SUBJECT: Comments on Draft EIS/OEIS, Guam and CNMI Military Relocation

Vol	Ch	Pg	Line, Tbl, Fig	Org	Commenter (last)	Comment	Responder
J-001	001	1	ES-4 ES-5	Guam EPA		<i>Proposed Actions</i> include a) Marine - Construction of infrastructure and facilities; b) Navy - Construction of new wharf with shoreside infrastructure; c) Army - Construction of infrastructure and AMTF	
J-001	002			Guam EPA		Each of the Volumes of the DEIS describe <u>general</u> activities related to the main components of the <i>Proposed Actions</i> described above. Considering the lack of specific information on all the materials to be used, the impact of solid, toxic and hazardous waste management has not been provided and therefore <u>cannot be adequately evaluated</u> for each of the specific activities described in the Volumes. Therefore, to facilitate clarity and consistency, Guam EPA recommends that a <u>separate Solid Waste Management & Disposal Plan</u> . <i>This Plan must include a waste composition study to address the anticipated wastes associated with each activity, its impact to the existing management options, and how will the waste streams be managed.</i>

Figure 1. Mapping the 7 water management zones of Guam.
(6 subsurface water lens sub-basins and one surface water area.)

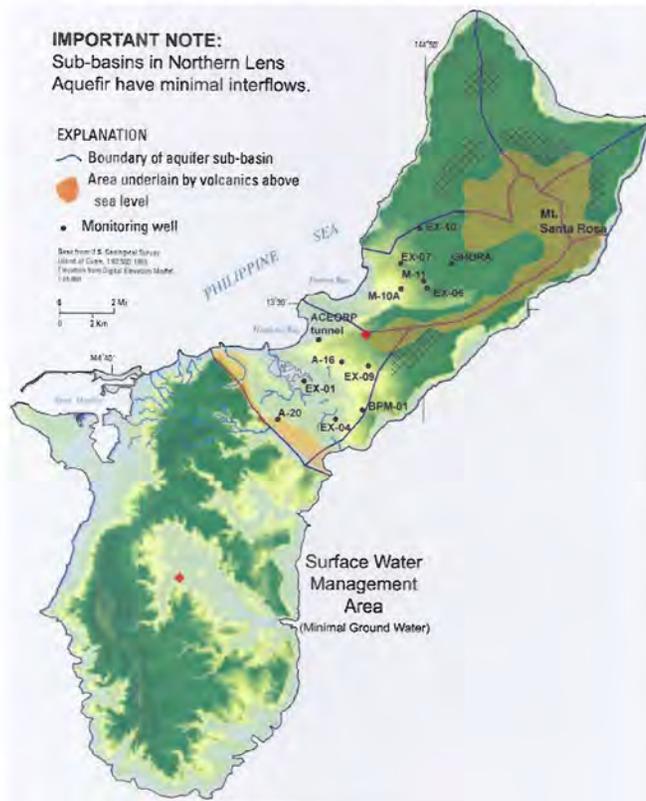
The NGLA is in fact composed of 6 sub-basins. (This excludes Southern Guam which realistically can serve mainly as a source of surface water.) [Please see “*Figure 1. Mapping the 7 water management zones of Guam*” below.] The necessity of managing the sustainable water supply on a basin by basin basis, while identified, has never been adequately quantified. The bulk of available data applies to the Yigo-Dededo Trough section through the middle and which is the largest single sub-basin.

The surface water management area of southern Guam (See “*Figure 1. Mapping the 7 water management zones of Guam.*” on page 10 above) was thoroughly studied by Barrett Consulting Group generating the 1994 report “*Guam Surface Water Development Study*”. This study provides the information that would allow GWA to maintain capacity for surface water production even through the worst drought on record in 1971-1972. In addition it provides the information necessary to manage future growth needs that can be satisfied by using surface water resources.

Thank you for your comment. The Guam Water Authority (GWA) and DoD are cooperatively working together to plan for the expected increase in population on Guam. DoD has agreed to drill the 22 new DoD water supply wells early, and provide this water to GWA, along with excess water from DoD's Fena Reservoir, to meet the near-term increase in water demand that is expected to occur off-base during the construction phase of the buildup. During this time, GWA will make improvements to their system to meet the long-term water needs of off-base communities. Concrete plans to resolve the projected shortfalls in the GWA water system must be in place prior to commencement of the DoD buildup. DoD and GWA are working on these solutions and they will be included in the final EIS.

Combining and integrating both the DoD and GWA water systems would be a major undertaking that is beyond the scope of the EIS. Also, it would cause DoD to lose control of their water systems to GWA, whose performance to date has not been exactly exemplary as they are under a stipulated order from EPA. At this point in time, DoD certainly plans on cooperating with GWA and assisting them to the full legal extent of their

Figure 1. Locations of the proposed development areas addressed in this analysis.

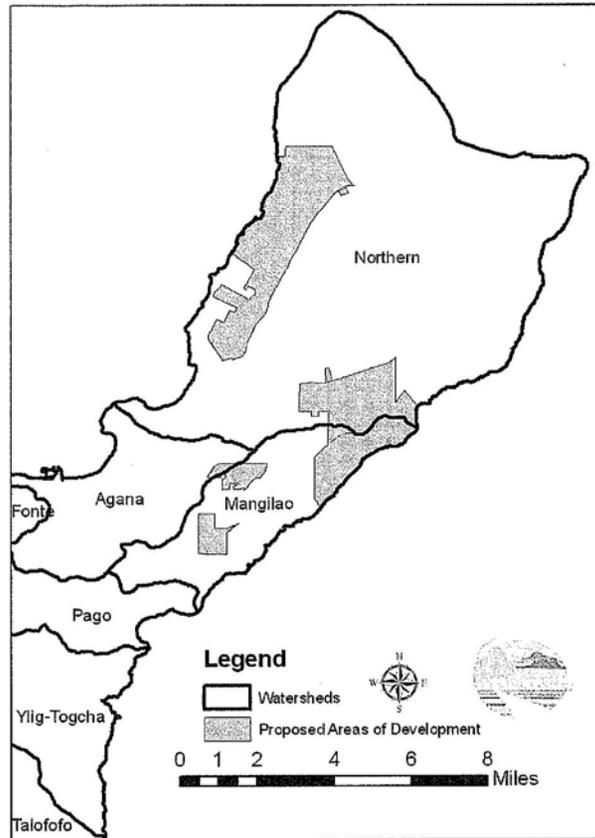
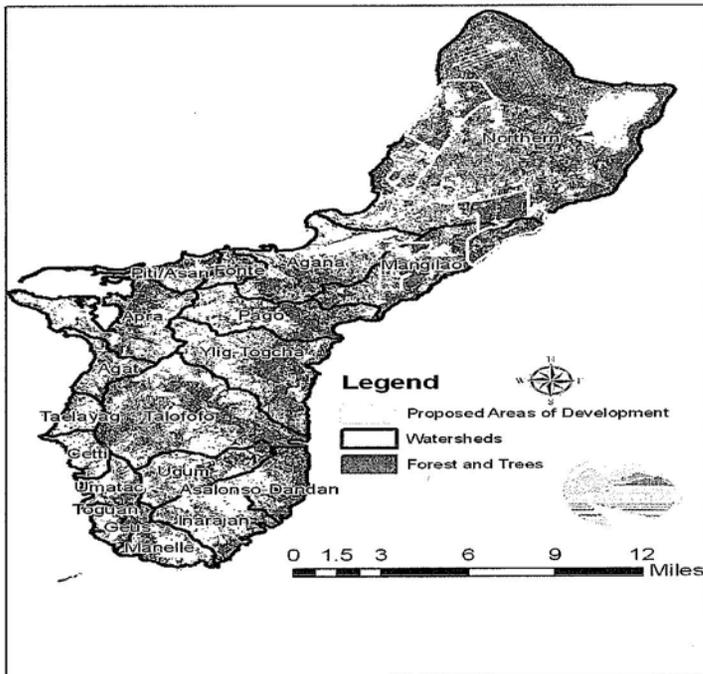
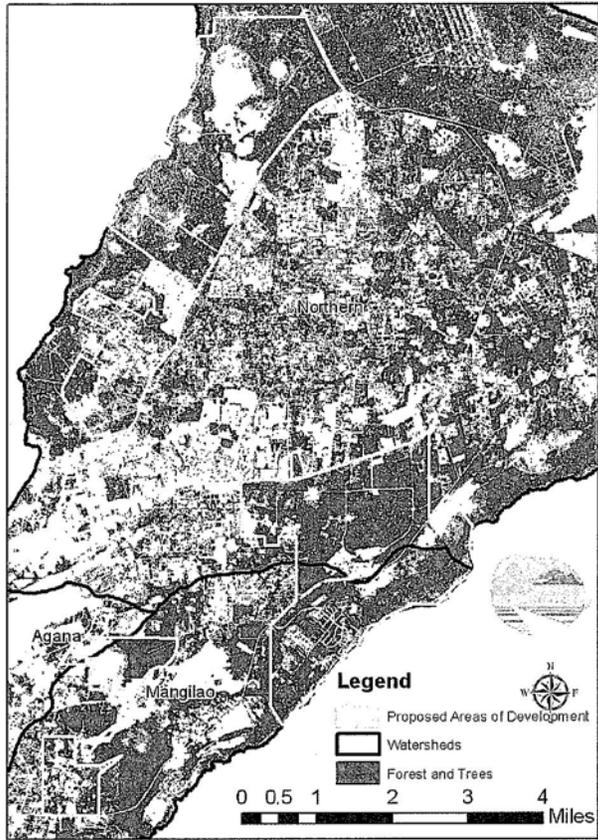
The proposed reduction of forest cover of up to 10% of the total forest cover of Guam is a significant impact that affects the viability of Guam's forests, including reductions in the benefits of forests: groundwater infiltration, potential habitat, biodiversity, and water quality.

Thank you for your comment and the analysis. Watershed erosion studies and projects are being considered as mitigation for marine impacts in Apra Harbor and other greenbelt plantings are being considered. Your recommendation for offset planting projects fits well with this planned mitigation and the Navy and Marine Corps looks forward to working with you on this initiative. The SWARS study that you are finalizing will be helpful to determine specific mitigation targets and methods. Your comment concerning your desire for involvement in community and urban forestry initiative for the proposed housing projects may not be feasible due to the limitations of space and timing for these particular projects.

Some of the information in your comments is incorrect: The total acreages that you project would be disturbed by the proposed EIS actions are much higher than the actual acreages that would be disturbed. The specific areas that would be disturbed are shown in figures and tables in the EIS and are broken out by vegetation type.

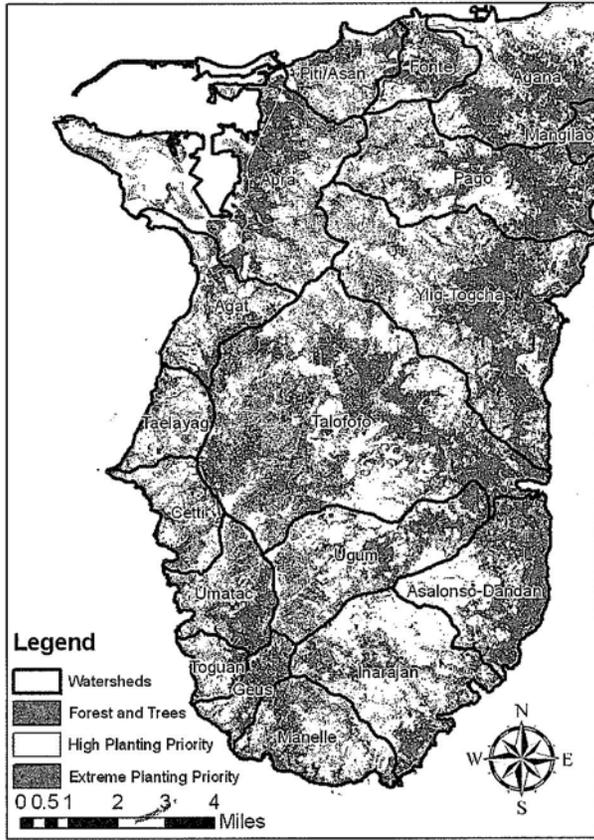
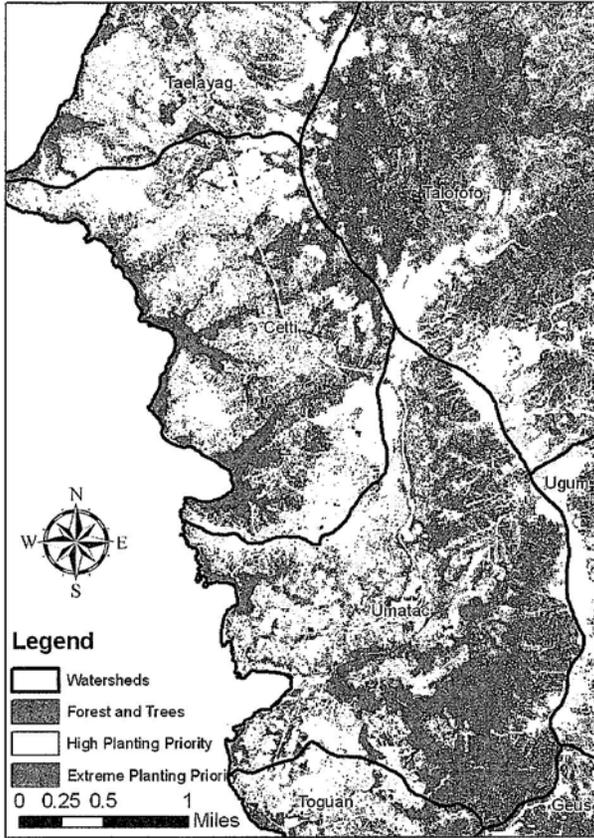
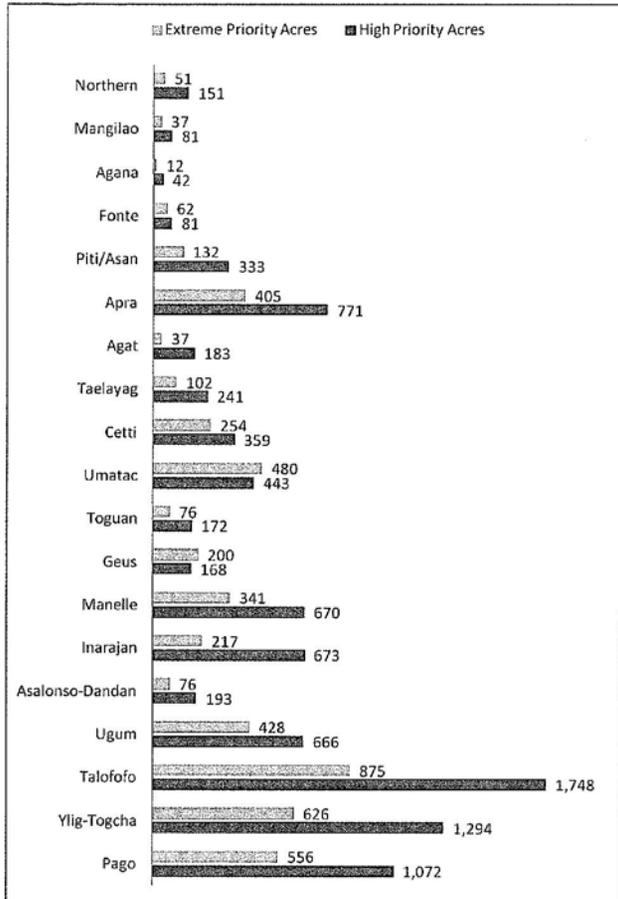
Preliminary SWARS results have been compiled that met the combined objectives of Mitigation Goal #2 above and are presented in Figure 4 and Figure 5. Overall, 8,906 acres are priority ranked to meet these objectives. Of these, 3,095 acres (35% of priority ranked areas) are designated as “extreme”, or having elevated risk of fire, sediment and/or fragment size; 5,811 acres (65%) are classified as having a “high” priority, having at least a moderate risk for all objectives.
